XL252 Full ESA Approach

Introduction

► X-AXIS

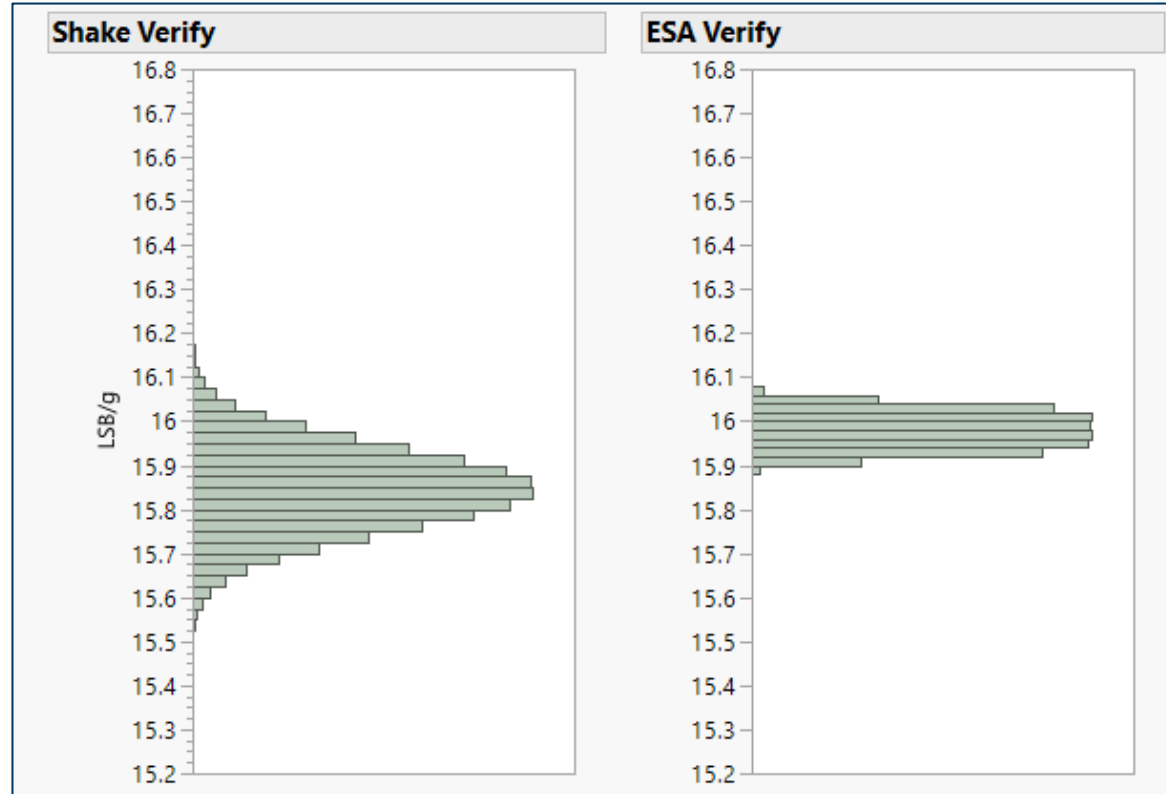
-40C X-Sens	Mean	Sigma	Cpk
Shake Sens	15.85	0.09	1.15
ESA Sens	15.98	0.04	3.92

► Z-AXIS

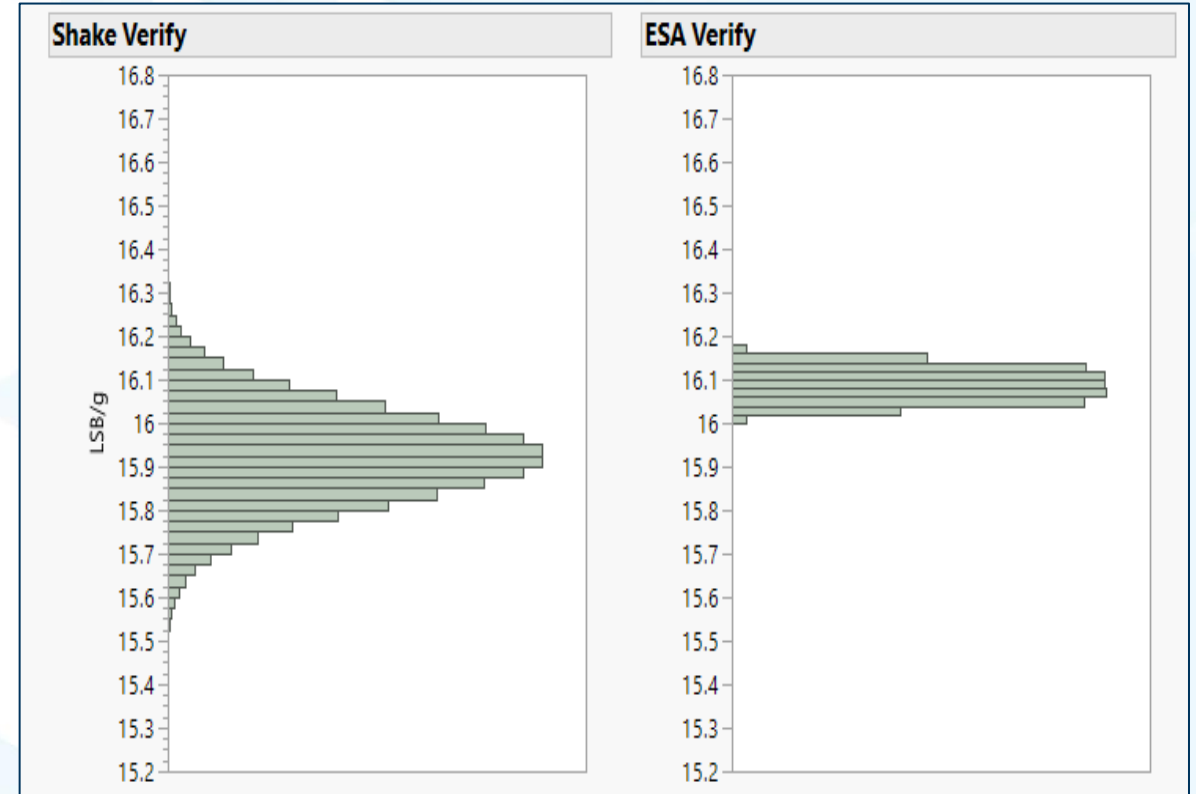
-40C Z-Sens	Mean	Sigma	Cpk
Shake Sens	15.92	0.11	1.19
ESA Sens	16.09	0.04	3.61
